## MEMORANDUM

**DATE:** January 31, 2014

**SUBJECT: **Setdown Report - ZC 13-17**** Brownstein Commons  
(Square 5933, Lot 45-49 and Square 5934, Lots 17, 18 and 806)

**Future Land Use Map**

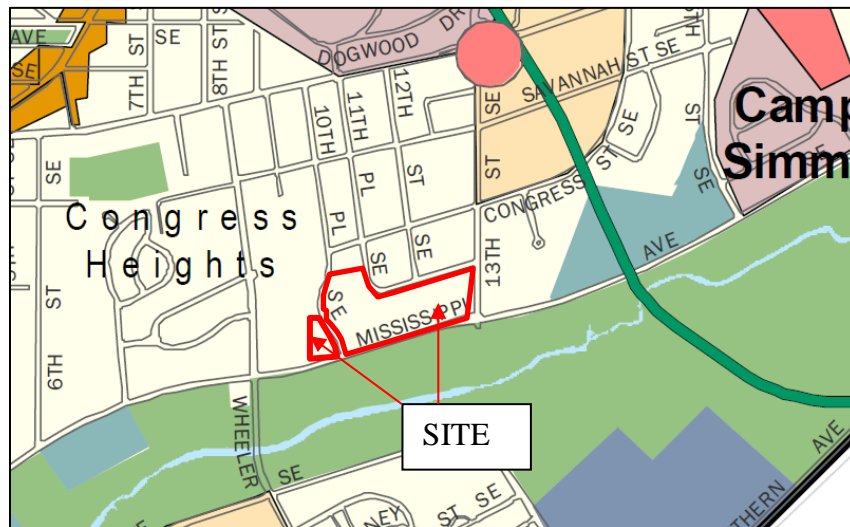
The Future Land Use Map recommends the subject site for moderate density residential.

The proposed R-5-B zoning and PUD is not inconsistent with this recommendation. The proposed development meets or furthers many of the policies of the Comprehensive Plan as outlined below.
